**Addendum No. 1**  
**February 15, 2017**

Project: Brandon Valley Middle School Office Addition & Remodel  
Brandon, South Dakota

Project No.: 2700

1  
 SD-4 SCALE: 1 1/2" = 1'-0"  
 REVISED DETAIL 9/5.31

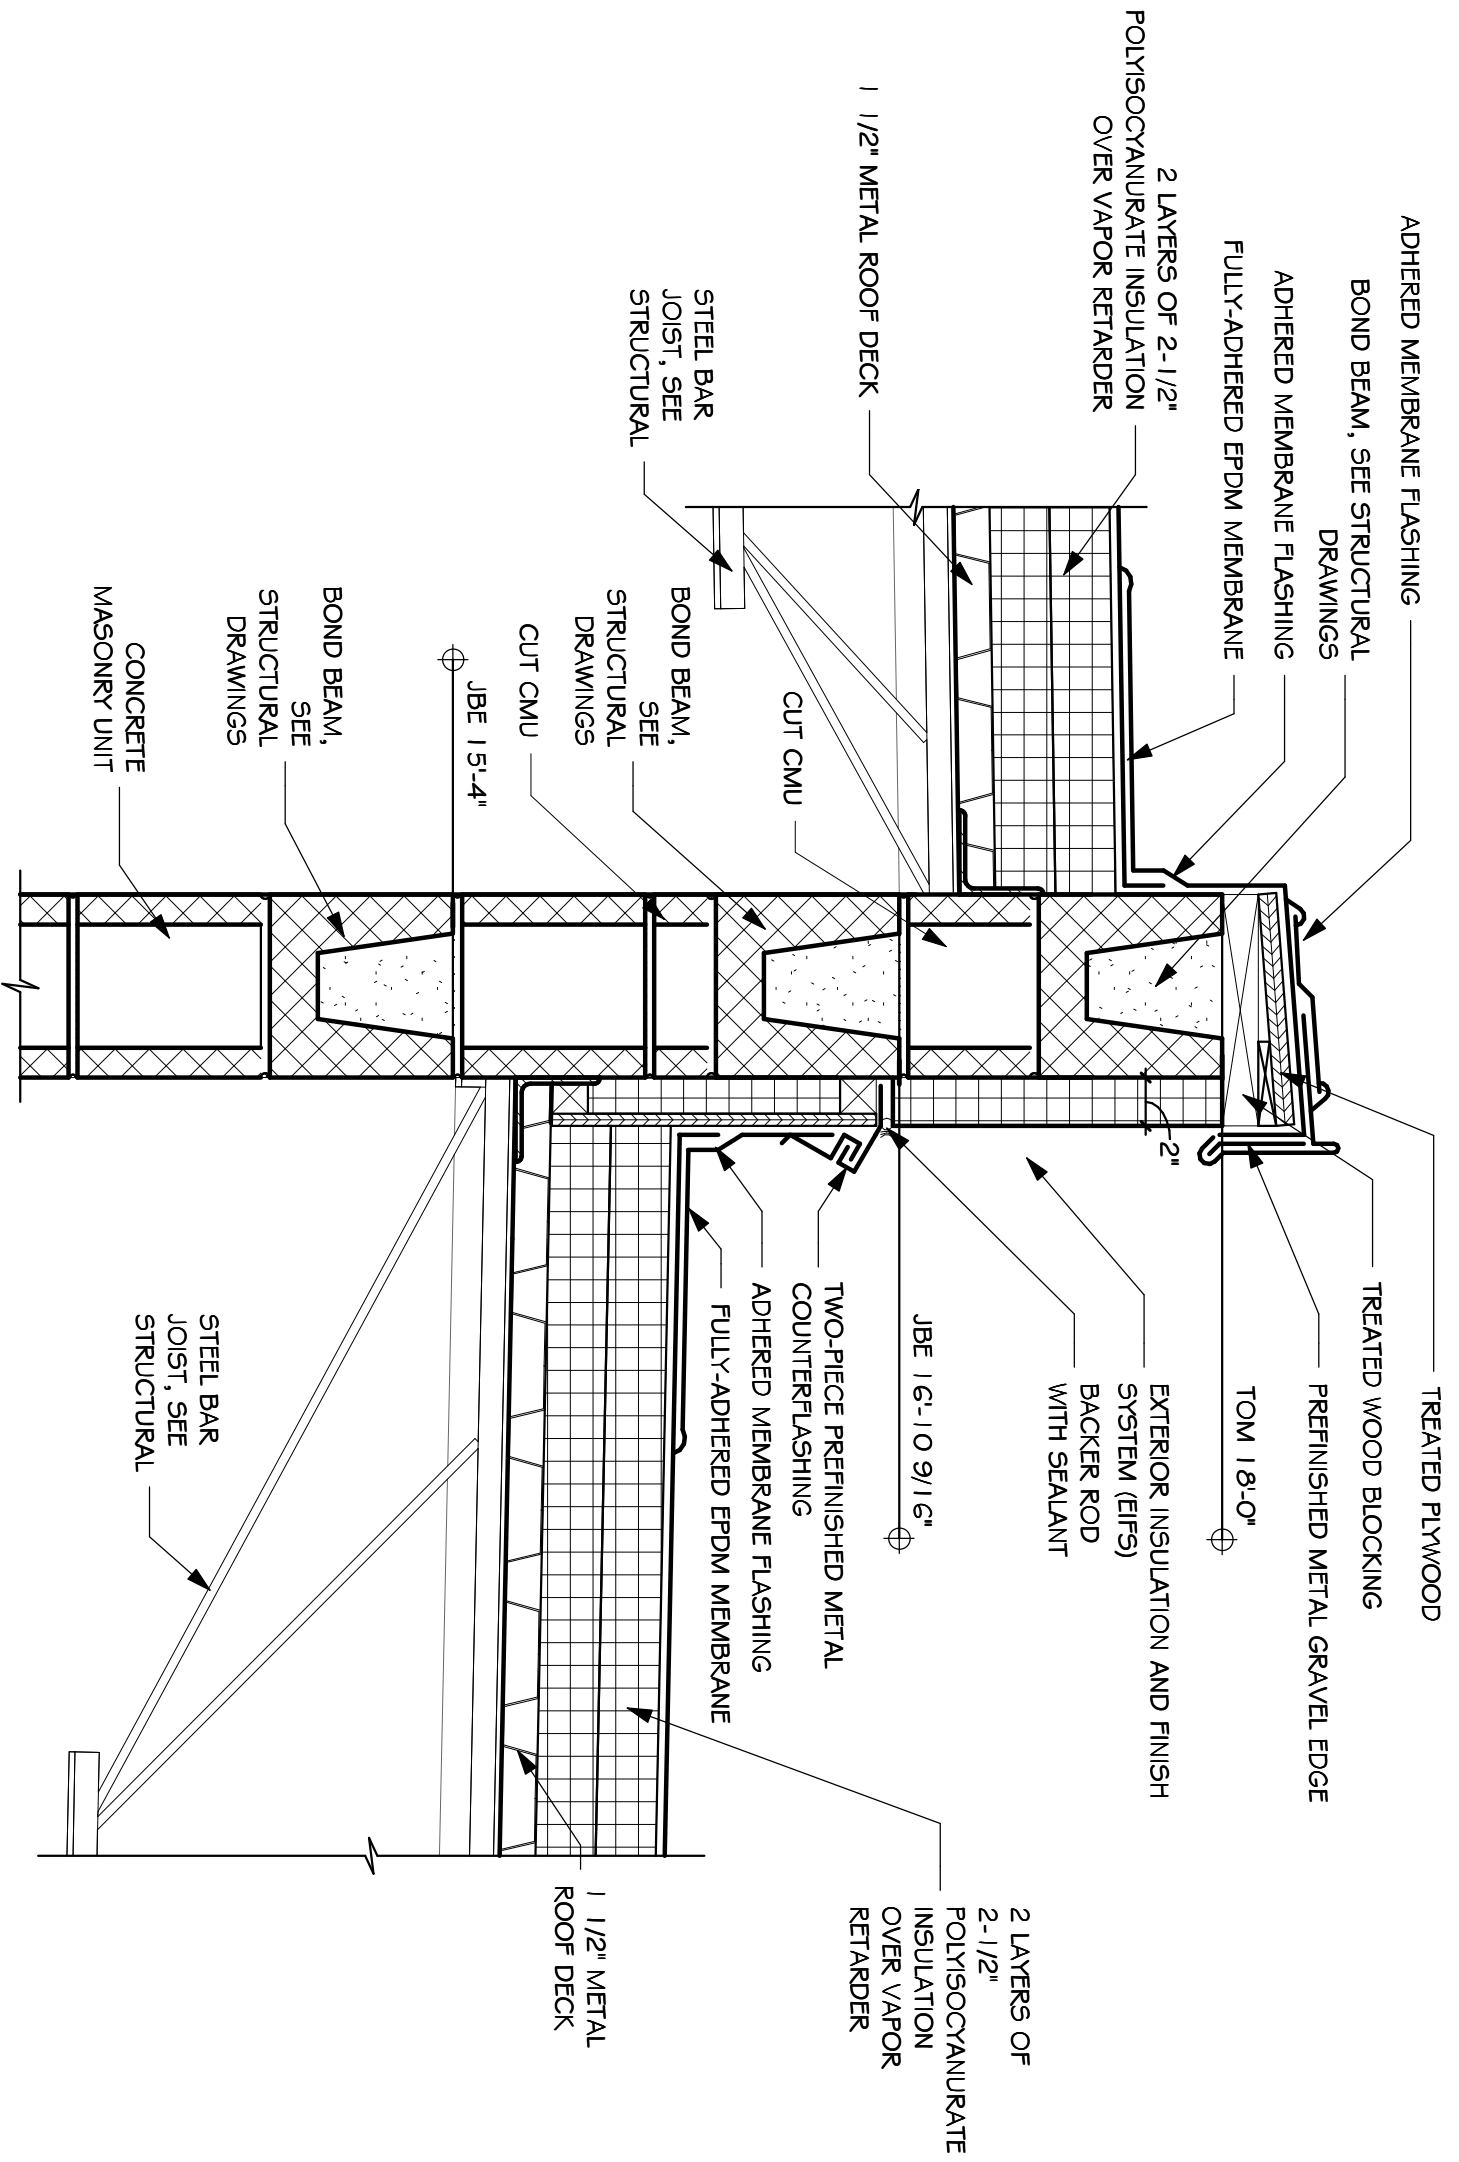
- a) Refer to Supplemental Drawing SD-9, attached to the end of this addendum, for revisions to Detail 2/5.30.
- 13) DRAWING SHEET 5.31
  - a) Refer to Supplemental Drawing SD-4, attached to the end of this addendum, for revisions to Detail 9/5.31.

1 REVISED DETAIL 1/5.5 1  
 SD-7 SCALE: 1 1/2" = 1'-0"

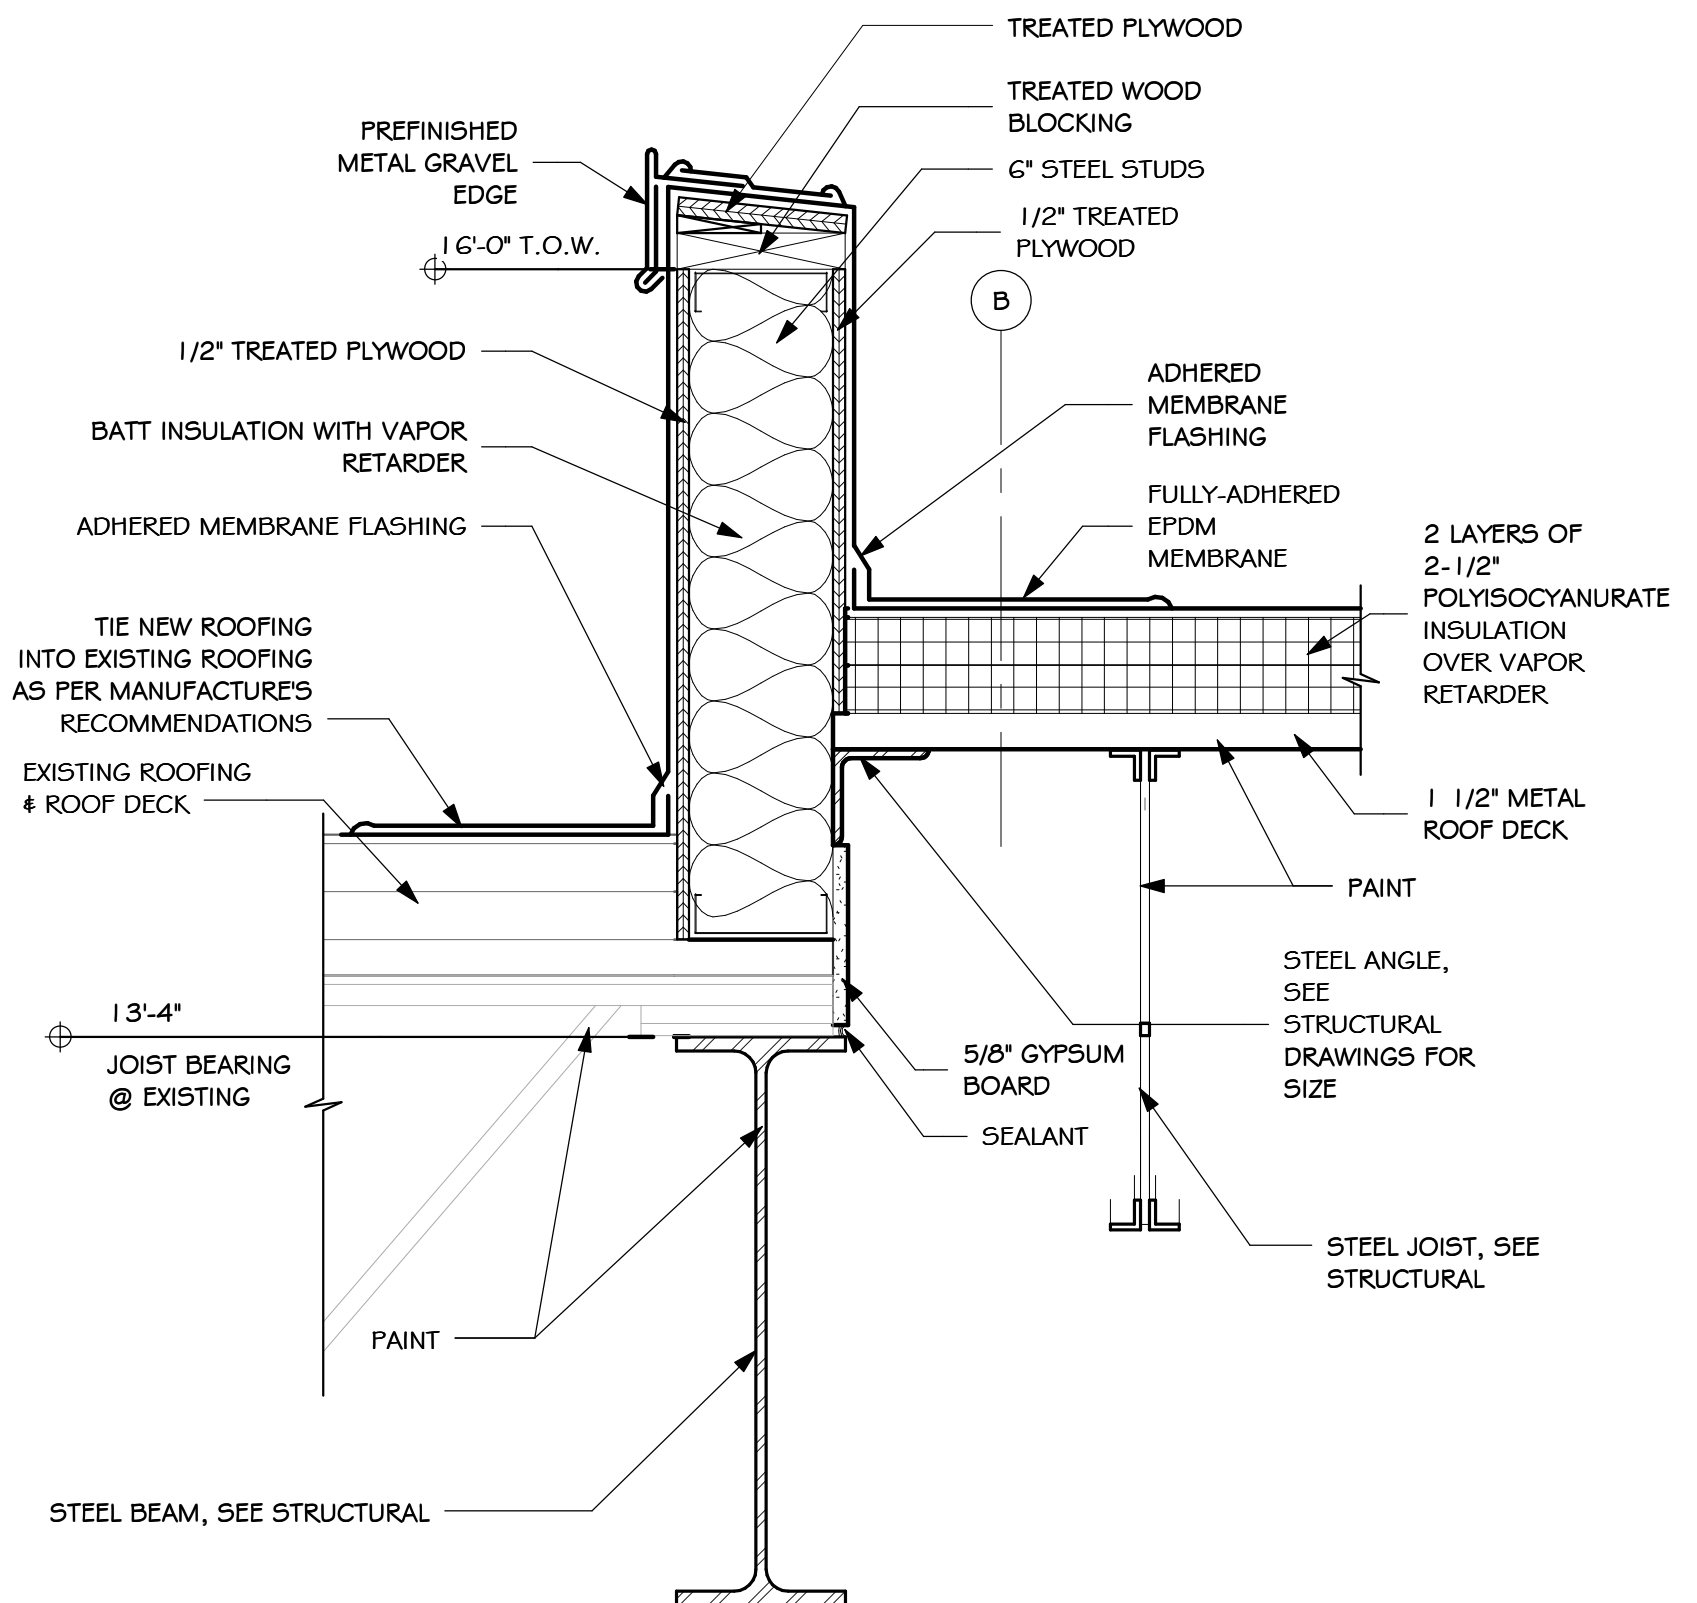
- a) Refer to Supplemental Drawing SD-7, attached to the end of this addendum, for revisions to Detail 1/5.51.
- 16) DRAWING SHEET 6.10
  - a) Refer to Supplemental Drawing SD-2, attached to the end of this addendum, for grille locations in ceiling at Vestibule 100.

1 PARTIAL FLOOR PLAN - AREA A  
 SD-8 SCALE: 1/8" = 1'-0"

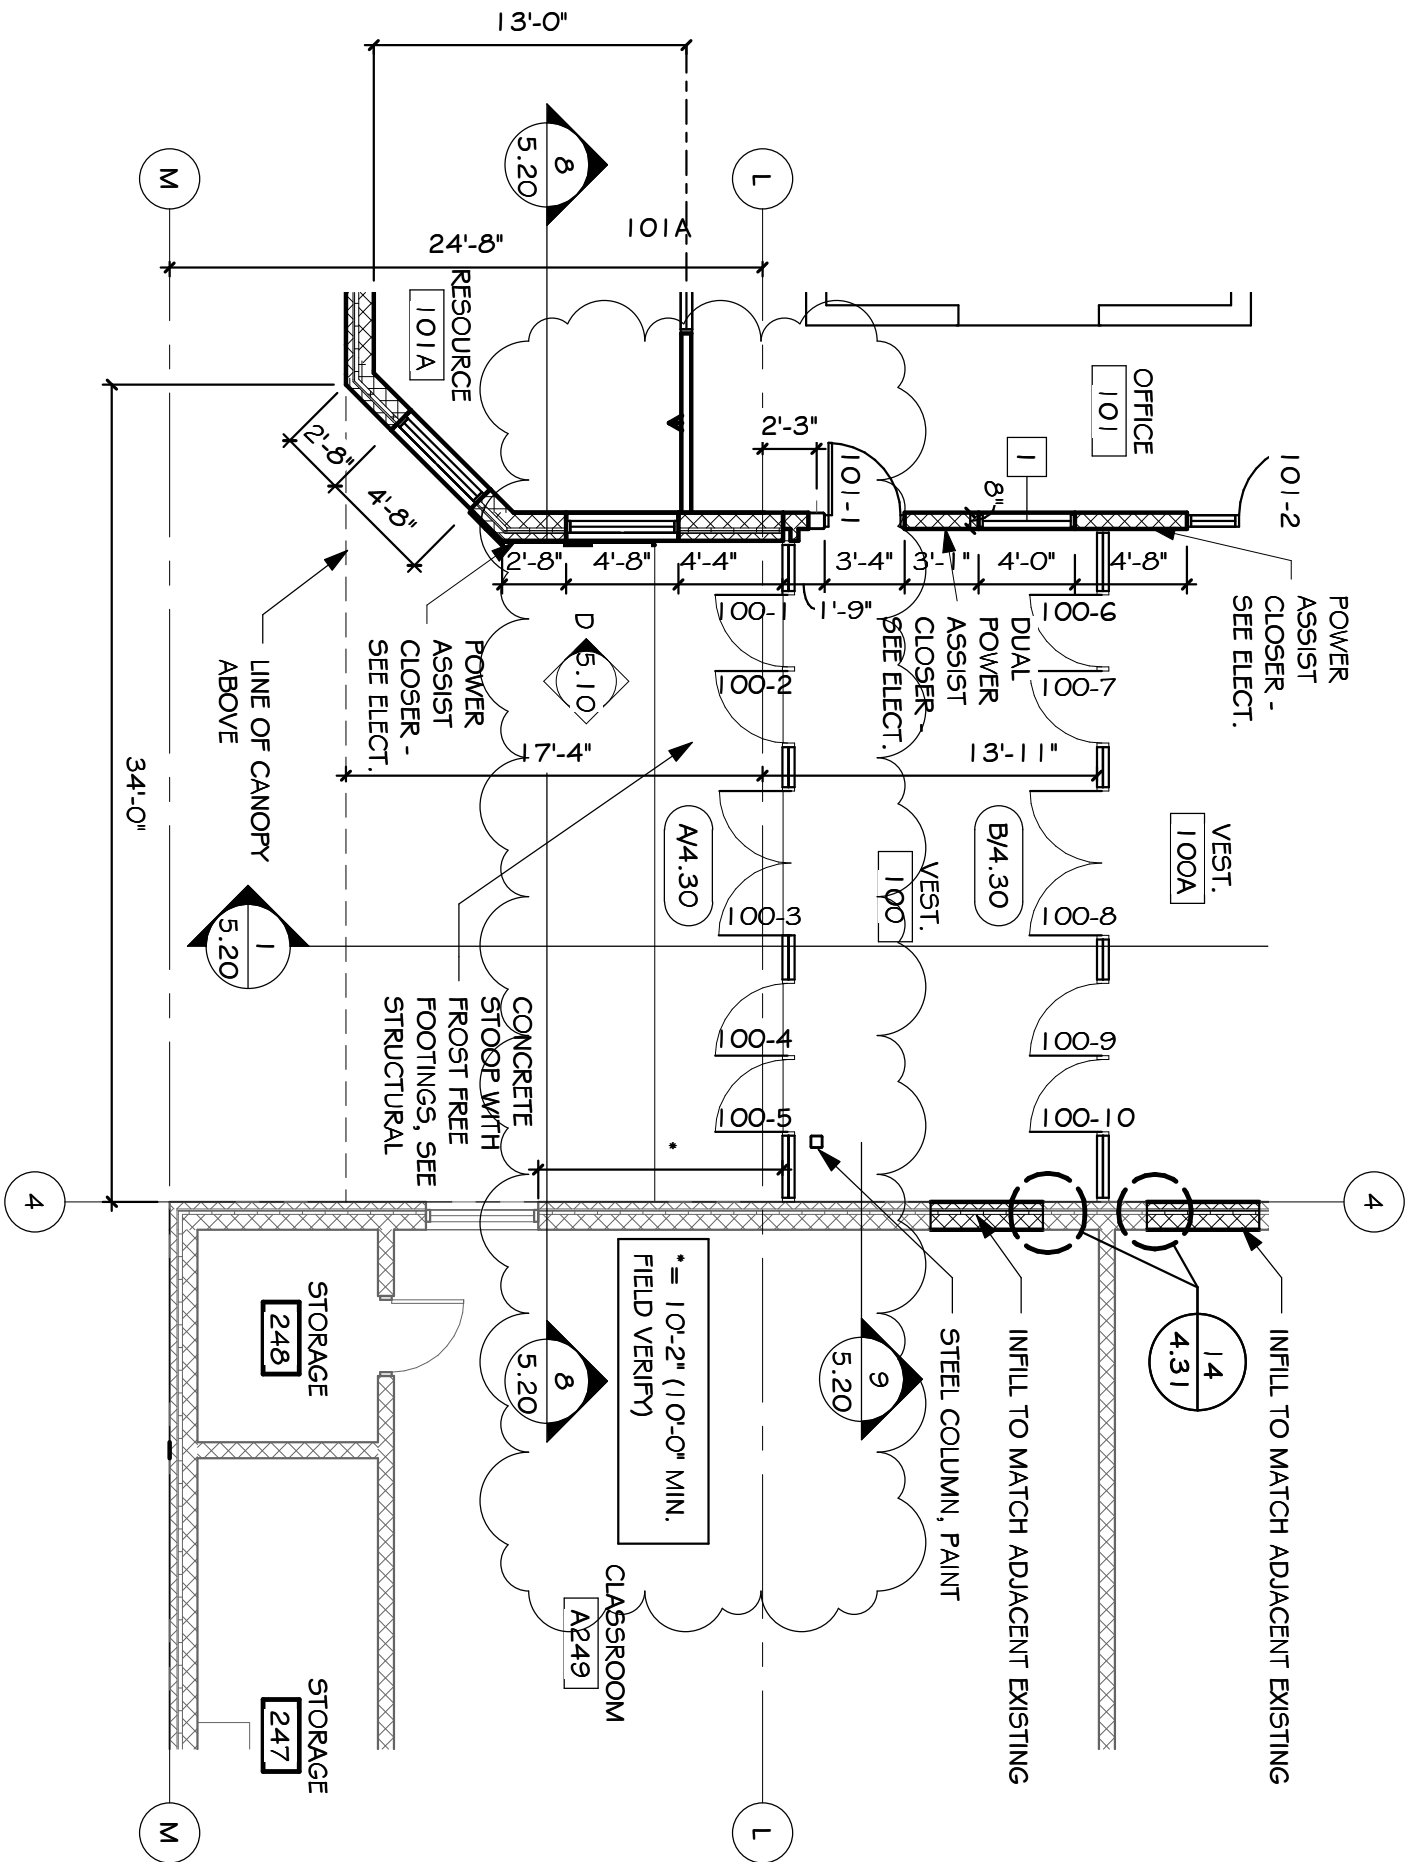
- 7) DRAWING SHEET 4.11
  - a) Refer to Supplemental Drawing SD-8, attached to the end of this addendum, for location of south wall of Vestibule 100.
- 8) DRAWING SHEET 4.12
